Title of Change:	Update to PB23734X-Tube Pin dimension and color change for TO247&TT3PN
Effective date:	24 Feb 2021
Contact information:	Contact your local ON Semiconductor Sales Office or Daisy.Zhi@onsemi.com
Type of notification:	This Product Bulletin is for notification purposes only. ON Semiconductor will proceed with implementation of this change upon publication of this Product Bulletin.
Change Category:	Test Change
Change Sub-Category(s):	Shipping/Packaging/Marking

This is an update from PB23734X to inform customer on the Tube Pin dimension and color change for TO247&TT3PN.

文書番号: PB23734X1

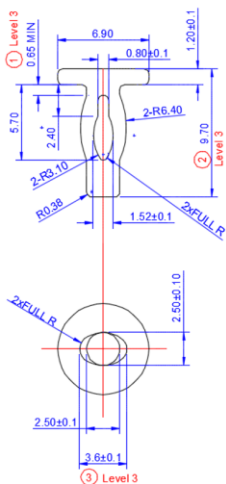
Tube Pin Dimension & Color Change

- 1. MATERIAL: NYLON
- 2. COLOR: GREEN/RED
- 3. STANDARD TOLERANCE = +/-0.20

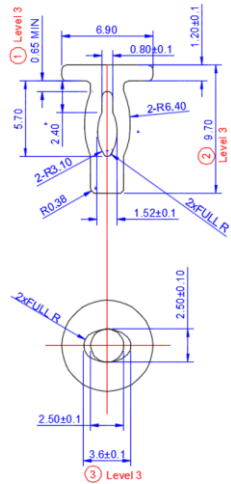
これは、PB23734X を更新し、TO247 & TT3PN のチューブピンの寸法と色を変更することをお客様にお知らせするものです。
チューブピンの寸法と色の変更
現在:

1. MATERIAL: NYLON
2. COLOR: GREEN/RED
3. STANDARD TOLERANCE = +/-0.20
